STAFF REPORT 06-22-2916 MEETING

APPLICATION NUMBER 16-4674

ADDRESS: 1566 BAGLEY

HISTORIC DISTRICT: CORKTOWN

1 SITE PLAN
 SP1.1
 1" = 10'-0"

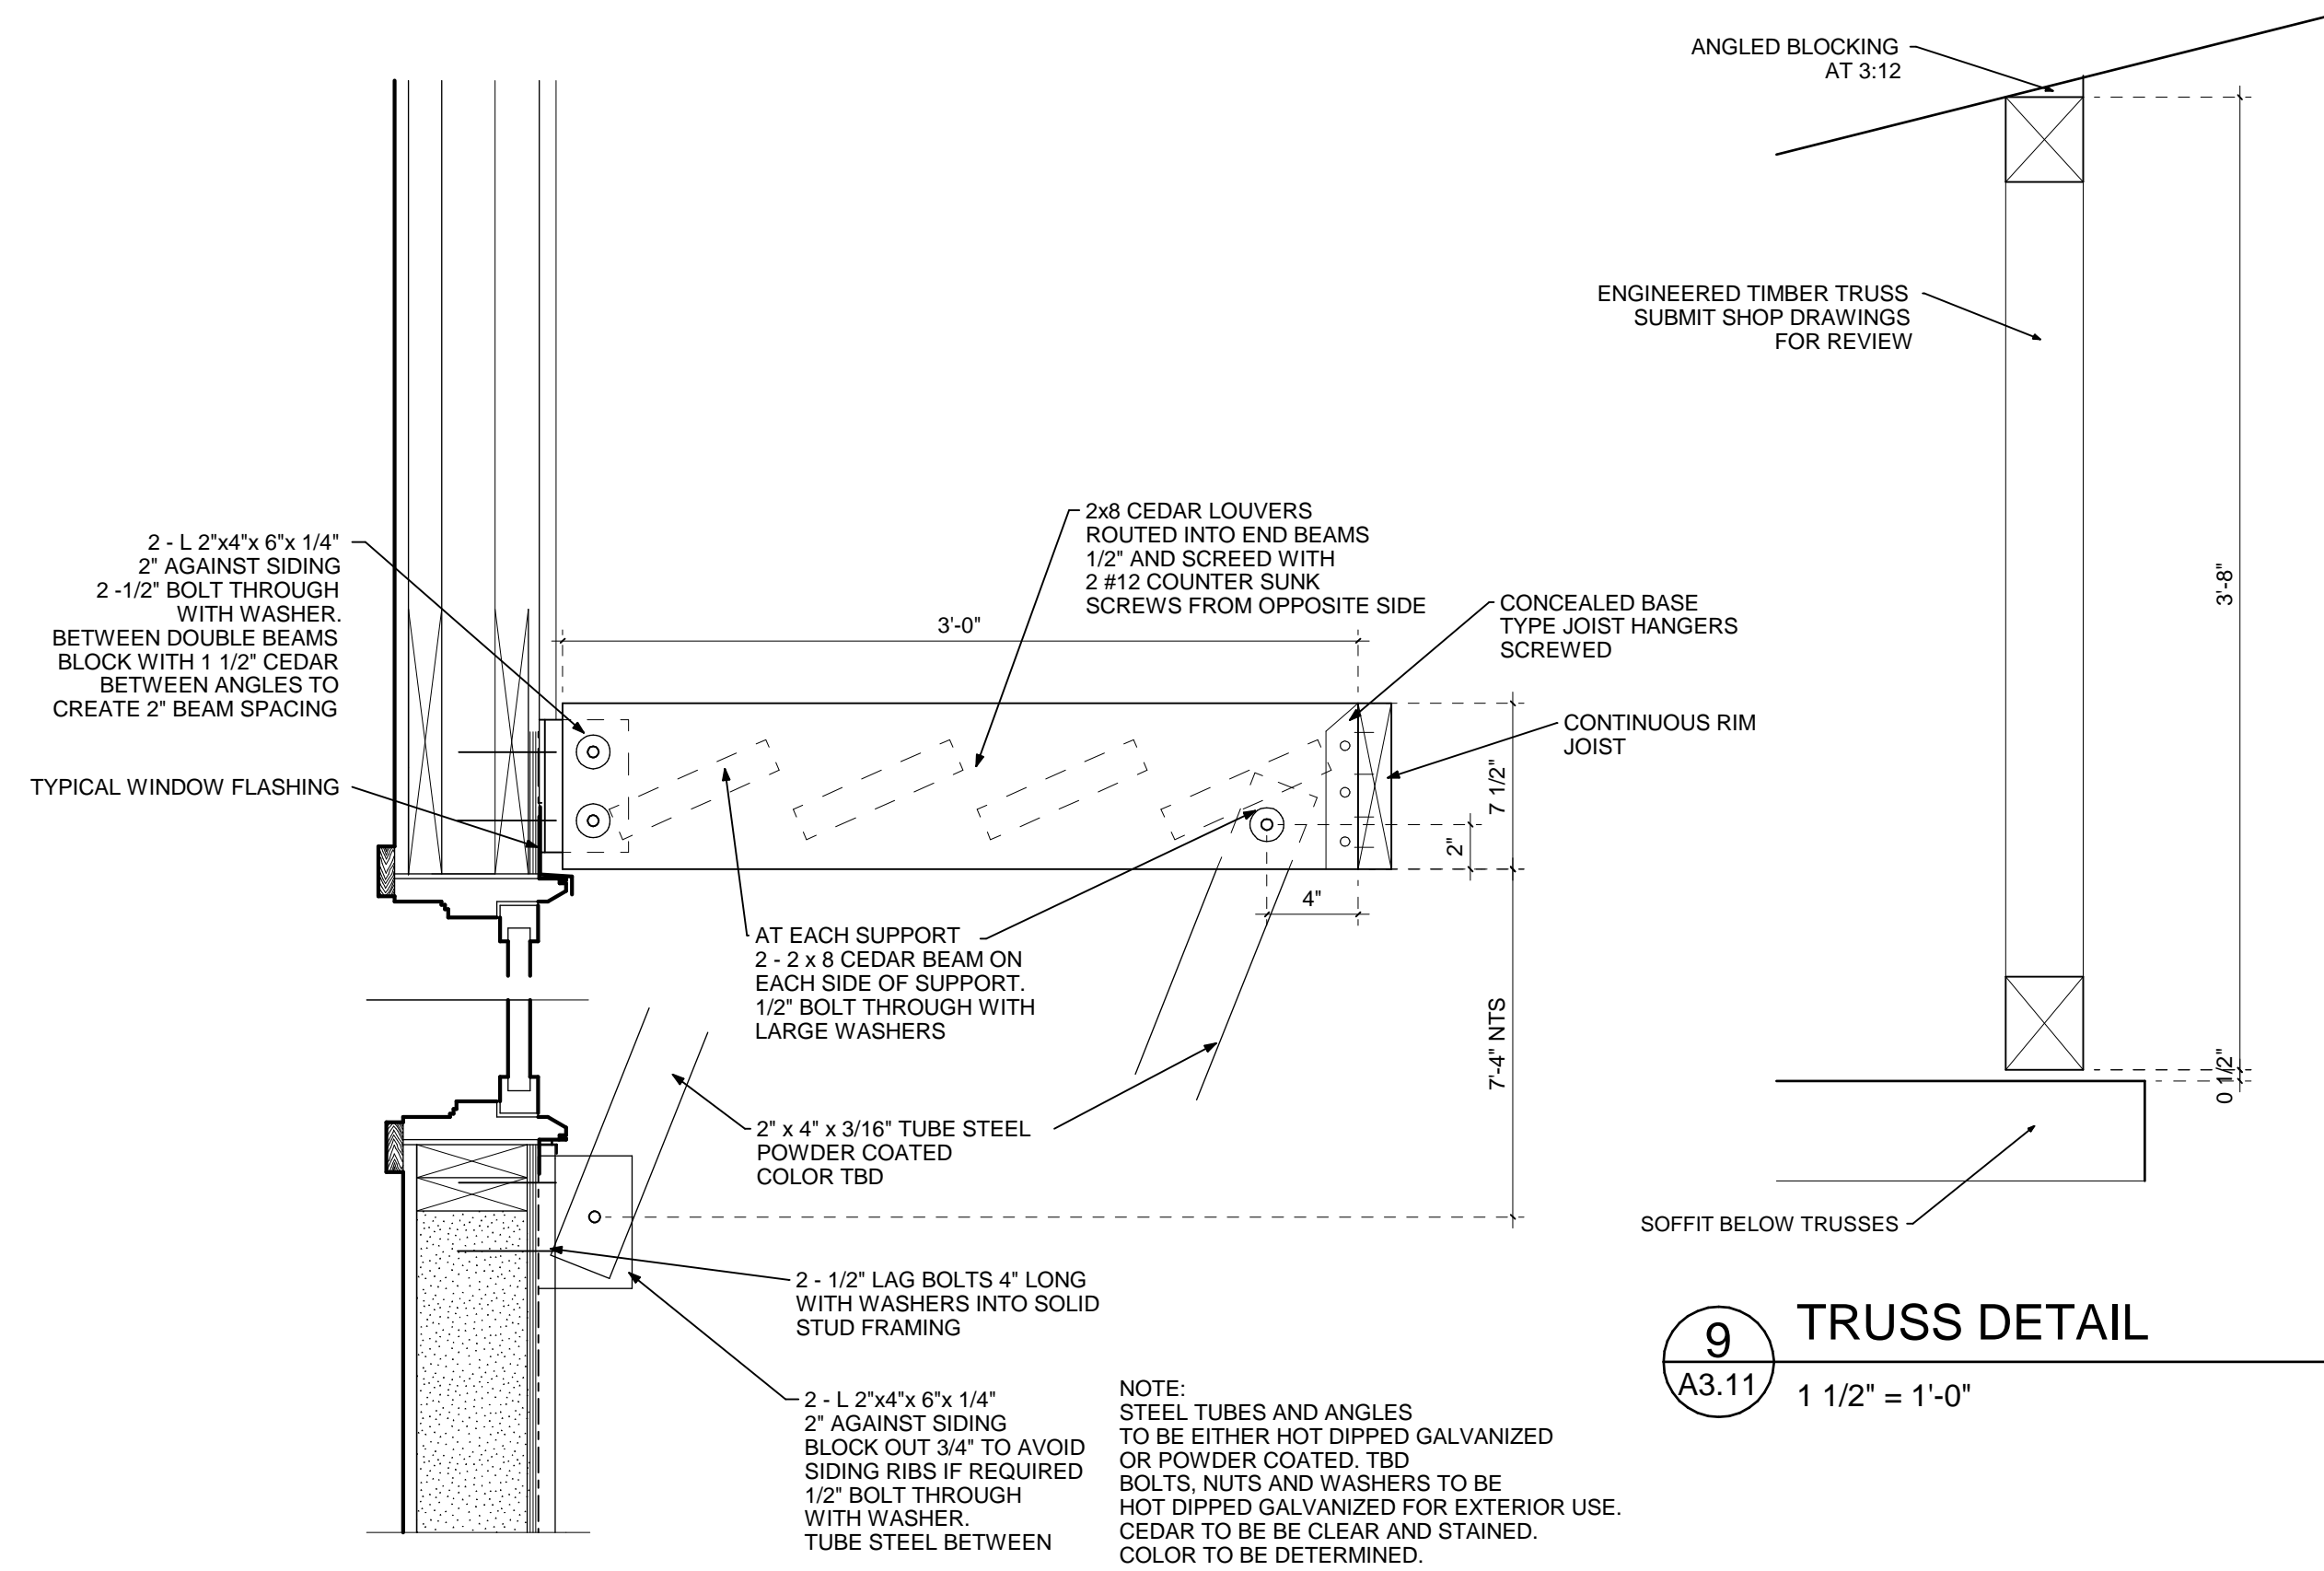
It is noted that the home's setback *is not* consistent with the existing architecture within the 1500 block of Bagley. Also, vertical metal siding is not commonly found at the exterior walls of residential properties within the district. Please see the following *Elements of Design* for the district which and note that the proposed design is generally not in keeping with the neighborhood's prevailing architectural character. However, please see the **submitted narrative** which outlines the applicant's purpose for locating the home to the rear of the lot and discusses their choice of material and the building design. Also, please see the **attached email** from the

- The home be pushed forward/south on the lot so that its setback is consistent with the two homes at the adjacent lots (the lots to the direct east). Staff shall be afforded the opportunity to review and approve the revised site/landscape plan before the COA is issued and the permit is pulled for the work. If staff feels that the site plan does not conform to the district’s Elements of Design, staff shall forward the work item to the Commission for a review at a meeting.

The location of the house 30 feet from the back property line and the alley, fits within the allowable setback but does not line up with the two house fronts on Bagley.

1. Bagley is a very mixed street with typical residential, industrial, apartment blocks and a suburban apartment complex with a variety of setbacks. It does not have a consistent context.
2. Within two blocks of this property there are three examples of buildings significantly set back from the street front. See the attached image. The clouded areas indicate buildings that are significantly set back from the street.
3. This property is an anomaly being a corner lot. The house in fact enters off of 10th street and, the placement set back, activates that street.
4. With the house setback we minimize the driveway as the parking is in a garage under the living portion of the house.
